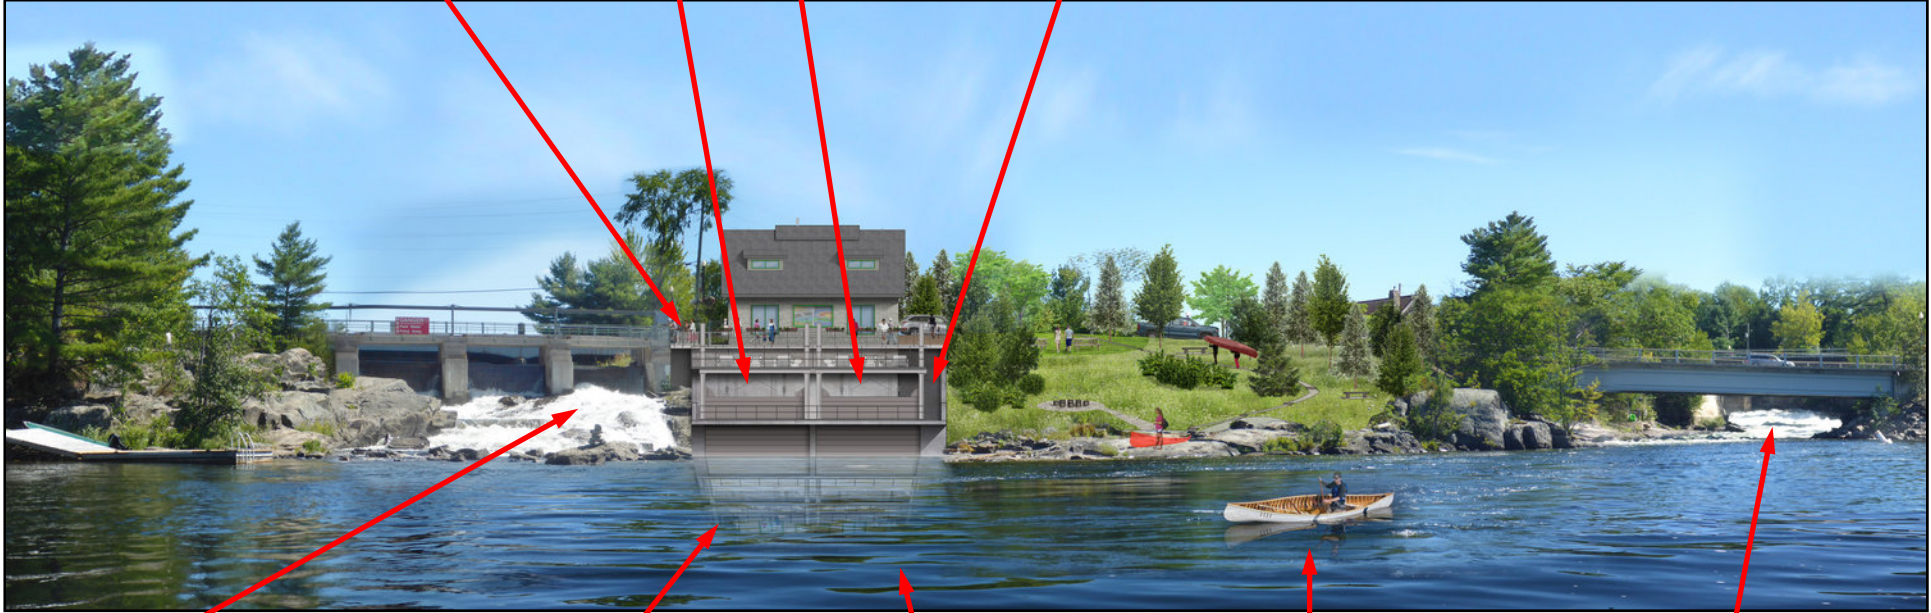
**Wrong.** There would be huge steel intake gates and hoisting beams here.

**Wrong.** There would be two 26'-high x 26'-wide steel tailrace gates, which would need to be in the up position during operation.

**Wrong.** There would be huge warning signs.

**Wrong.** The proponent would divert 94% of the water from both falls through their proposed generating station. So there would **only be a trickle** here.

**Wrong.** Where is the fluorescent yellow proposed downstream safety boom, extending 65' out into the Moon River.

**Wrong.** This guy is about to canoe into the dangerous, yet unmarked water exiting the proposed generating station.

**Wrong.** Only a trickle here too. People won't come to Bala to see the dry rocks where the falls used to be.

**Wrong.** There would be treacherously-turbulent water exiting the proposed generating station. This proposed Bala generating station would have more than ten times the flow of the nearby Wilson's Falls generating station, and that tailrace flow caused the drowning of a 16-year-old boy in 2008.
